**SUBDIVISION REVIEW SHEET**

**CASE NO:** C8-2009-0118.5A.SH

**SUBDIVISION NAME:** BRADSHAW CROSSING SECTION 7

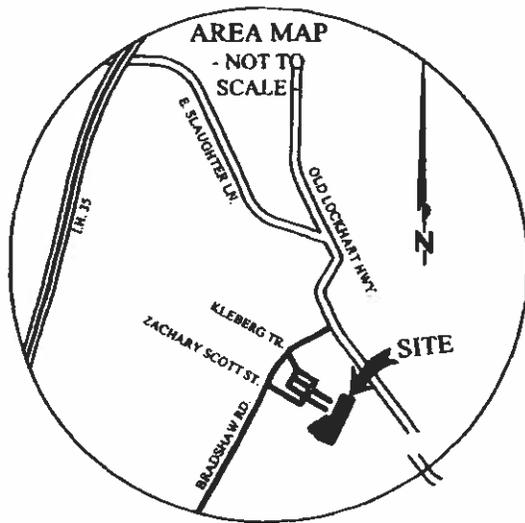
The request is for disapproval of the final with preliminary plan. The subdivision will be composed of (71) lots on 12.998 acres. COA will provide water service and wastewater service as well as electric service.

The staff recommends disapproval of the final with preliminary plan. The plat does not meet all applicable State and City of Austin LDC requirements. Staff will continue to work with the applicant to ensure compliance.
